NEPEAN HOSPITAL & INTEGRATED AMBULATORY SERVICES REDEVELOPMENT STAGE 2

(SSD-16928008)

ARCHITECTURAL DESIGN STATEMENT RESPONSE TO SUBMISSIONS

Level 4 and 8 Roof - Plant Room Screening

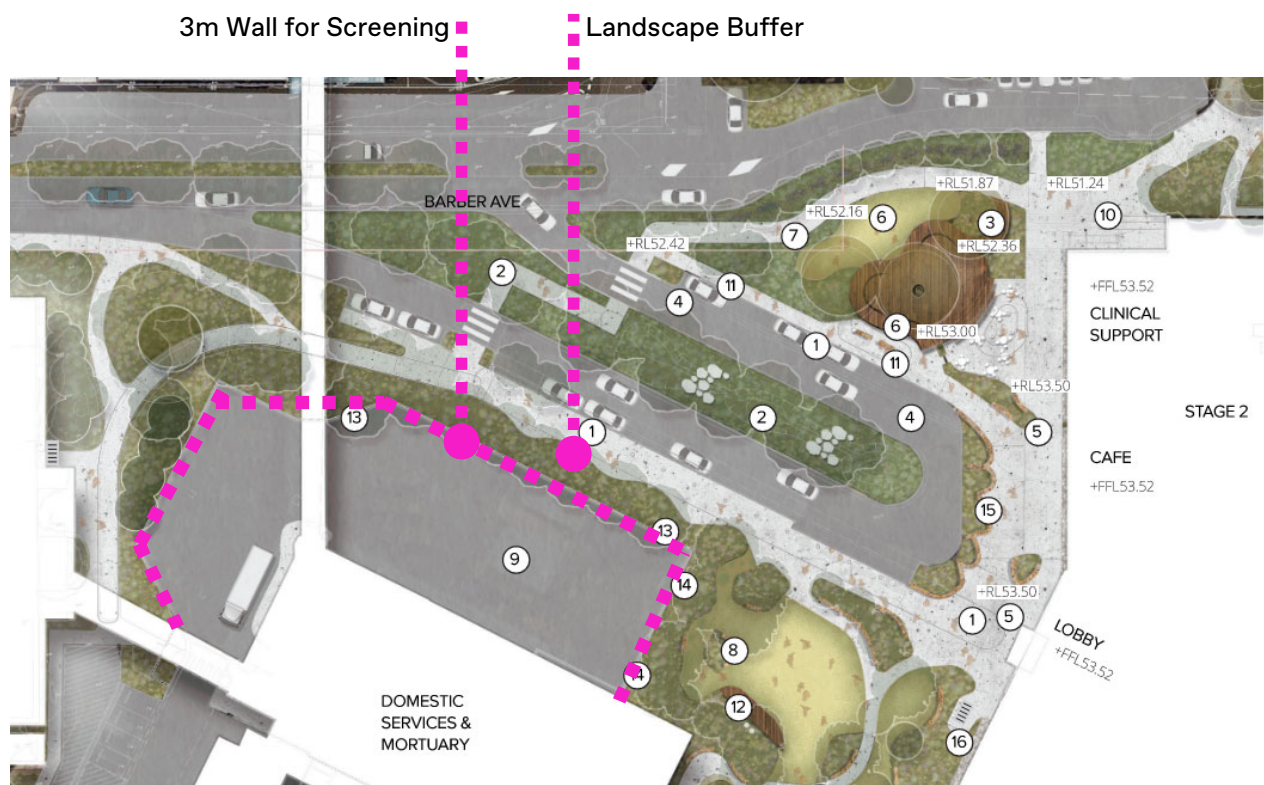
The Design Team further developed the SSDA design as part of Design Development, in particular reviewing plant room locations on the Level 8 roof.

All roof top plant rooms are fully enclosed and have louvres generally integrated into the tower facade systems. This will provide a consistent reading of the facades where large louvre areas are required for plant rooms on Level 4 and the Level 8 roof, closely tying in with the plant room screening implemented throughout Tower 1.

Roof top plant rooms have been consistently set back from the building edges, using dark grey coloured louvre screens to reduce potential visual impacts.

F02

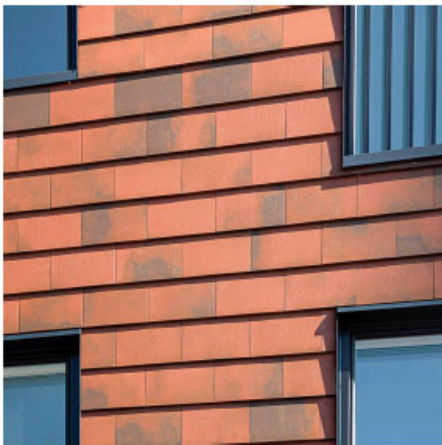
UPDATES TOWER 2	RESPONSE Reference Section / Appendix
FACADE	
<ul style="list-style-type: none">The proposed Terracotta finish to the facade and sunshade has changed from a profiled and natural finish to a flat tile in a red flamed, varying finish for all Tower 2 Terracotta facades.	<p>Refer to the following architectural drawings:</p> <ul style="list-style-type: none">Elevations A0-300 seriesFacade Sample Board NHR-BVN-DRW-ARC-TB2-A0-450

DESCRIPTION:
SUBSTRATE ON STEEL FRAME WITH TERRACOTTA (NATURAL) TILE
SYSTEM. RED FLAMED FINISH

DESCRIPTION:
SUNSHADE TERRACOTTA LOUVRE SYSTEM WITH INTEGRATED HOOK
SYSTEM. RED FLAMED FINISH

Northern Facade Updates

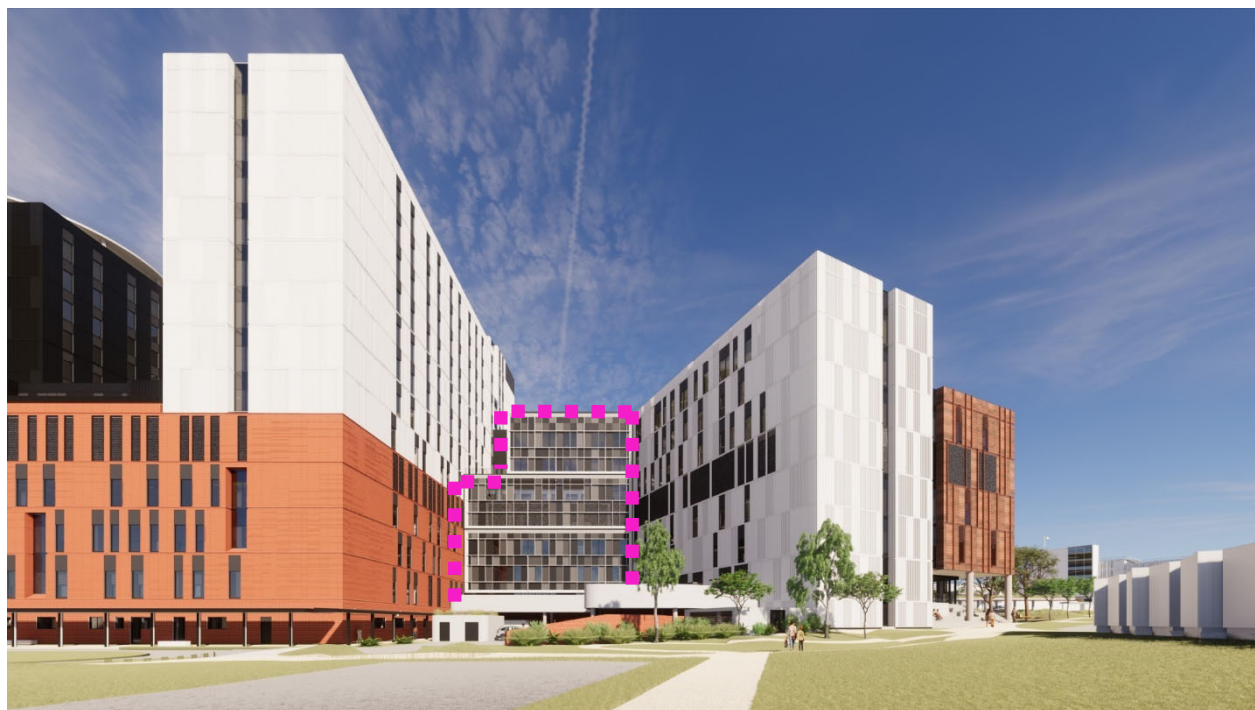
UPDATES TOWER 2	RESPONSE Reference Section / Appendix
FACADE	
<ul style="list-style-type: none">• The North Façade had minor adjustments to window & louvre locations throughout to accommodate changes in internal Clinical Planning.• The sunshade framing has been adjusted to suit final window locations.• The Level 7 terrace was removed to to accommodate changes in internal Clinical Planning and facilitate better plant provisions on the L8 roof.	<p>Refer to the following architectural drawings:</p> <ul style="list-style-type: none">• Plans A0-200 series• North Elevation NHR-BVN-DRW-ARC-TB2-A0-301
